COMPREHENSIVE GROUND WATER MONITORING EVALUATION

**VERNITRON PIEZOELECTRIC INCORPORATED
(MORGAN-MATROC INCORPORATED)**

OHD 052324290

MARCH 31, 1995

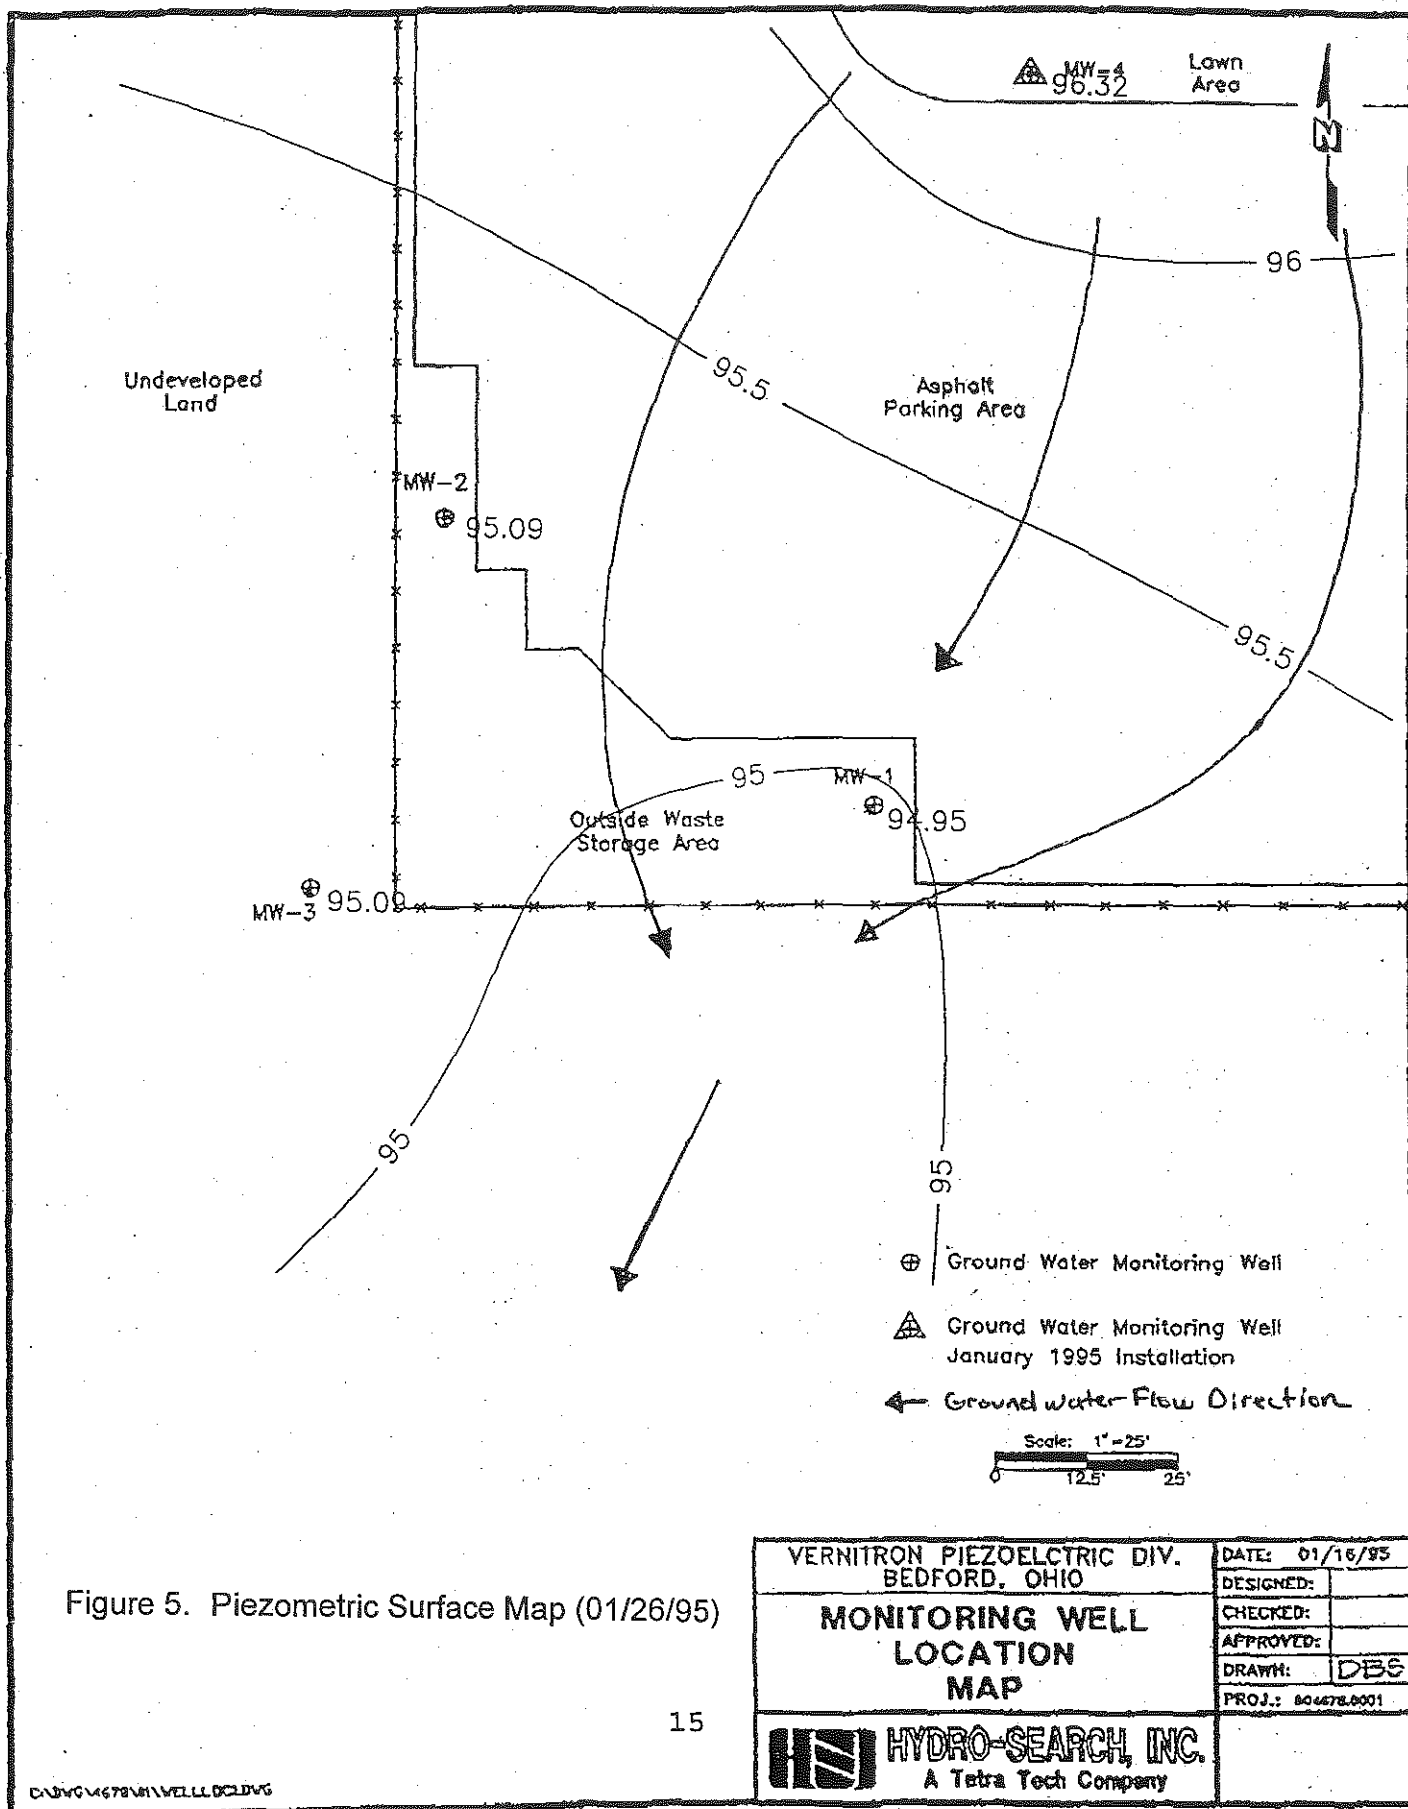
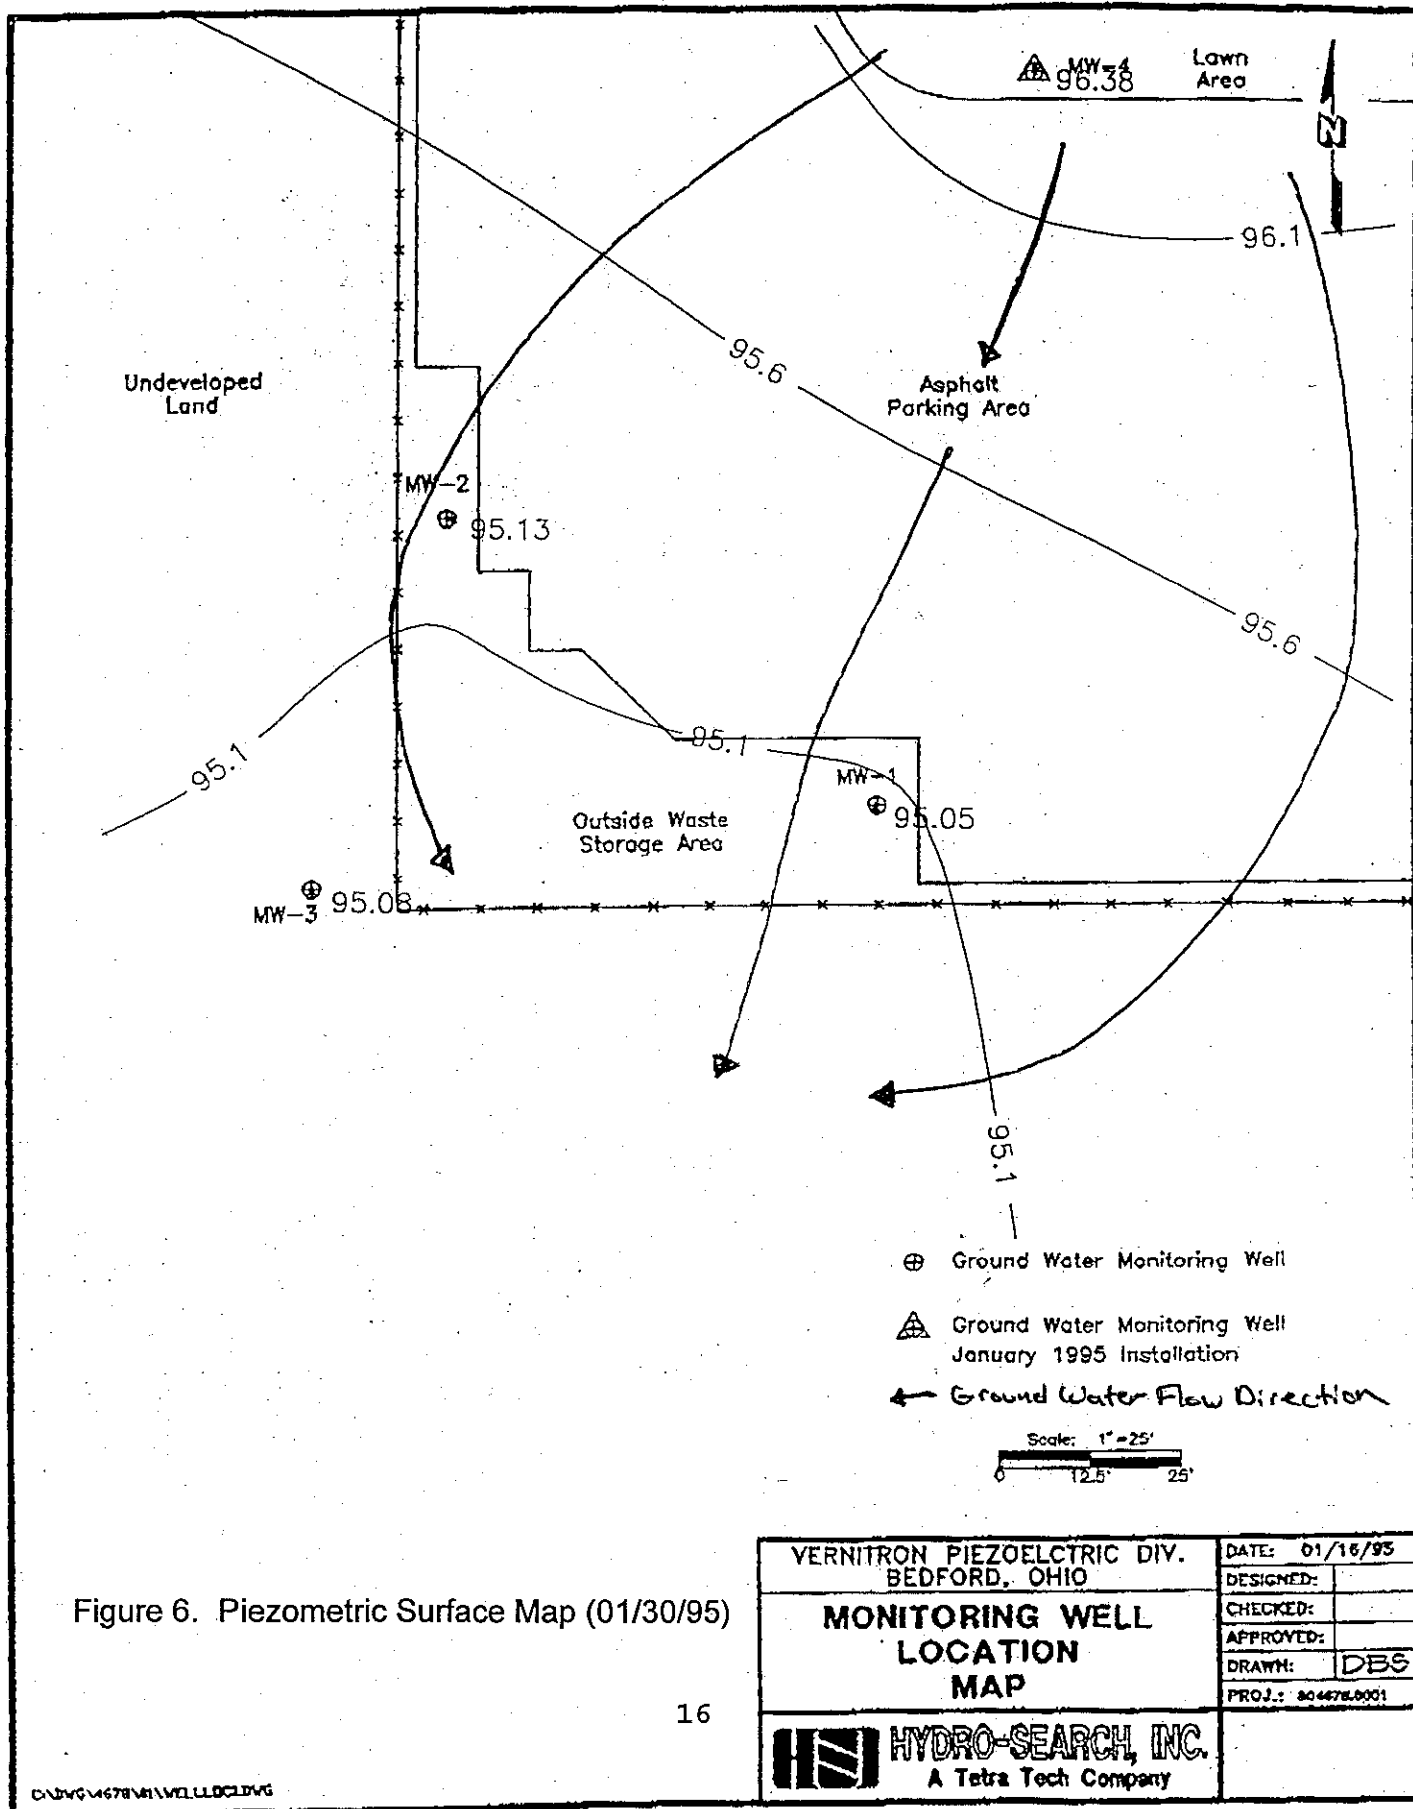
Additional ground water elevation data were collected on January 26 and January 30, 1994. Figures 4 and 5 are piezometric surface maps (with flow lines) that were constructed from the January data. The water level elevation data collected in 1995 indicate that the ground water flow direction may shift locally toward the southeast in the vicinity of MW-3. This apparent shift in ground water flow direction may be the result of seasonal or temperal variations. However, insufficient water level elevation data currently exist to define such variations. Recently the wells were modified from a flush mounted completion to an above ground completion. It is also possible that the apparent shift in ground water flow direction may be the result of a surveying error of the reference point. A ground water elevation data summary (1989-1995) is provided in Table 1.

- 22a. The most recently collected water level elevation data may not be valid. The data indicate a shift in ground water flow direction. However, it is unclear at this time whether this apparent change in ground water flow direction is the result of seasonal or temporal variations in flow or to an error in surveying the recently installed well risers.
